July 31, 1981

Docket No. 50-348
Docket No. 50-364

TEMPORARY CHANGE TO OPERATING LICENSE
NO. NPF-2 AND NPF-8 TECHNICAL SPECIFICATIONS

FIGURE 1
 TURBOSUPERCHARGED
 8 1/2 x 10 O.P. ENGINE
 12 CYL. CROSS SECTION

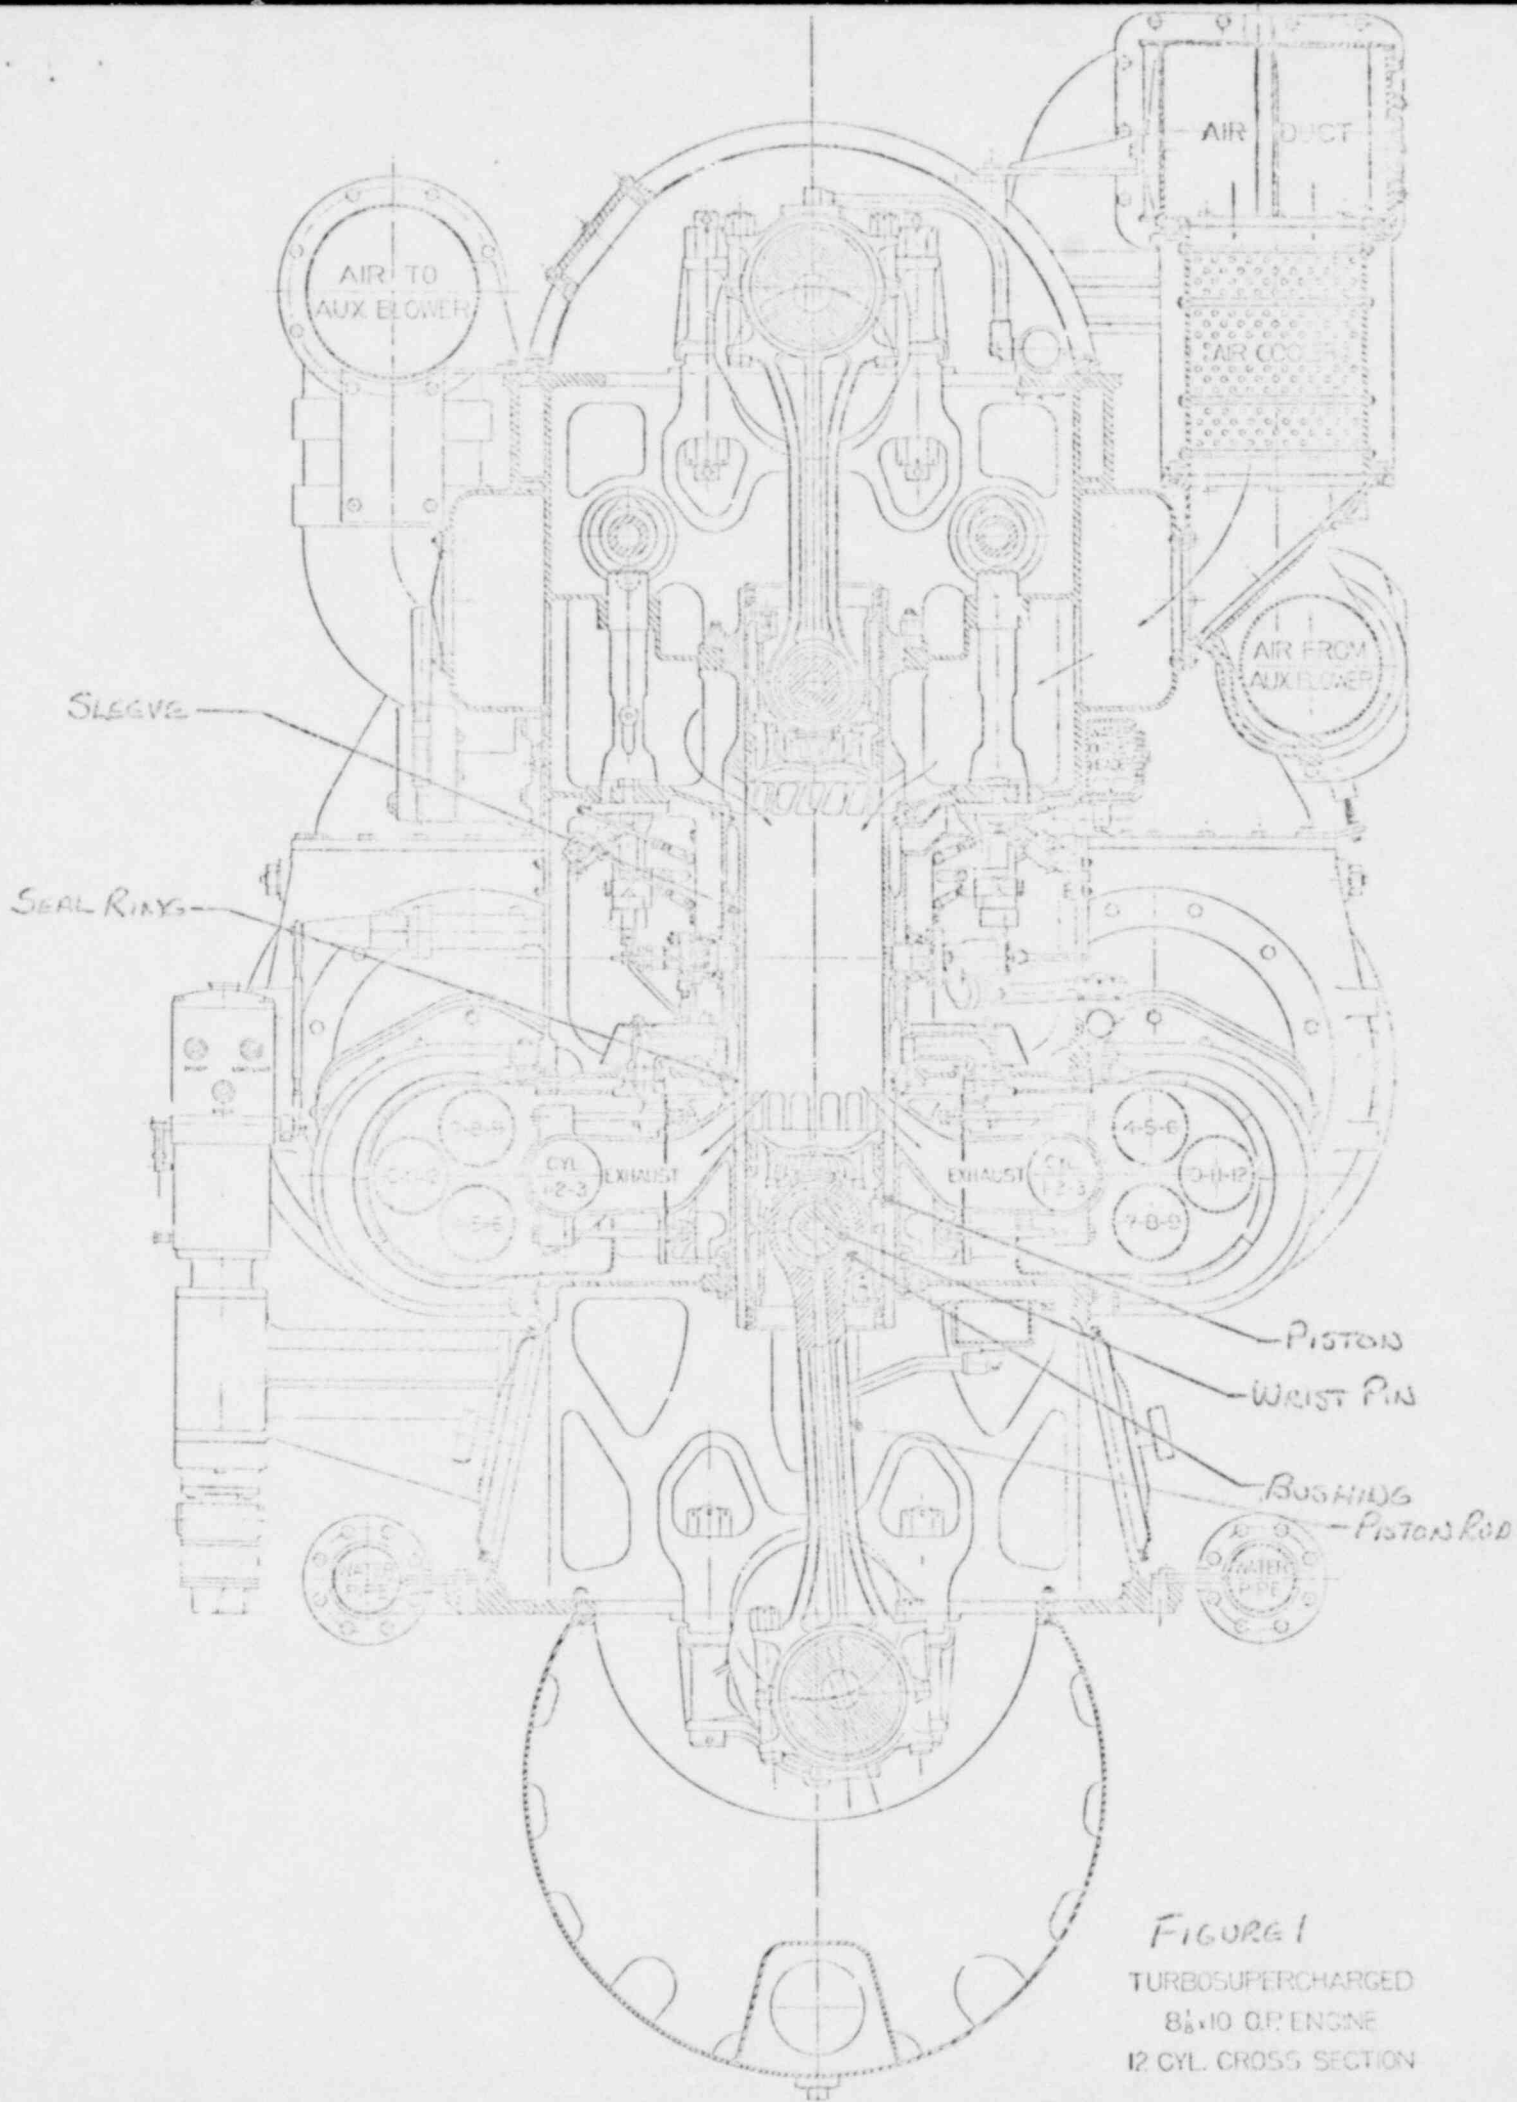
While attempting to perform the routine 1 hour synchronous load surveillance test (Section 4.8.1.1.2.a.5) on Diesel 1C, it was determined that jacket cooling water had entered the liner of four cylinders. The problem was discovered at 12:50 a.m. on July 30, 1981 and the diesel declared inoperable. On further investigation of the number 11 cylinder, the wrist pin and bushings connecting the upper piston to the connecting rod were badly worn, the O-ring between the jacket water system and the air intake system was failed, and the number 11 piston and cylinder were badly scored (shown in Figure 1). It is believed that the wrist pin and bushings, after becoming excessively worn, induced nonsymmetrical forces between the piston and the liner. Such nonsymmetrical loading caused a scuffing of the liner and the piston generating severe amounts of heat, thereby causing O-ring failure. Due to O-ring failure, water entered into the number 11 liner. Water was distributed to other cylinders through the air intake system while the engine was at rest. In addition excessive play between the upper and lower crankshaft was found upon disassembly.

Currently, Alabama Power Company, with a team of engineers and technicians from Colt Industries, is undertaking a thorough investigation/repair program. Such program began the morning of July 30, 1981. Assuming the failures and subsequent damage is confined to that described above, engine disassembly, troubleshooting and repair, engine reassembly, and replacement of lubricating oil along with attendant engine run in and operability tests is scheduled to be completed within nine (9) days of the date of the problem discovery. More explicitly this repair will include replacement of the liner, O-rings and gaskets, upper and lower pistons, upper wrist pin and bushing for the number 11 cylinder, and repair of the upper and lower crankshaft connecting assembly. In addition, pins and bushings in the remaining upper pistons will be inspected and replaced as necessary.

A hydrostatic test to verify satisfactory repair and to verify the adequacy of the remaining cylinder O-rings and gaskets will be performed. If damage is more extensive or if the failures involve other causes (e.g., liner cracking) the return to service time could be longer than the present schedule.

Alabama Power requests a revision to the Appendix A Technical Specifications for Units 1 and 2 included as Attachment 1. This one time exception would allow a six (6) day extension to the L.C.O. for repair of Diesel 1C while operating Units 1 and 2. In addition, Alabama Power Company proposes to demonstrate the operability of the remaining A.C. sources by performing surveillance requirements of Section 4.8.1.1.2.a.4 within one hour and at least once per 72 hours rather than within one hour and at least once per 8 hours thereafter. Due to expected time required to repair diesel generator 1C, approximately 120 starts on the remaining diesels would be required by Section 4.8.1.1.2.a.4. The diesel manufacturer does not recommend the testing frequency required during the period needed to repair diesel generator 1C due to potential accelerated wear. In addition, all transmission lines feeding the Farley Nuclear Plant switchyard are currently operable with no interruptions scheduled during this repair.
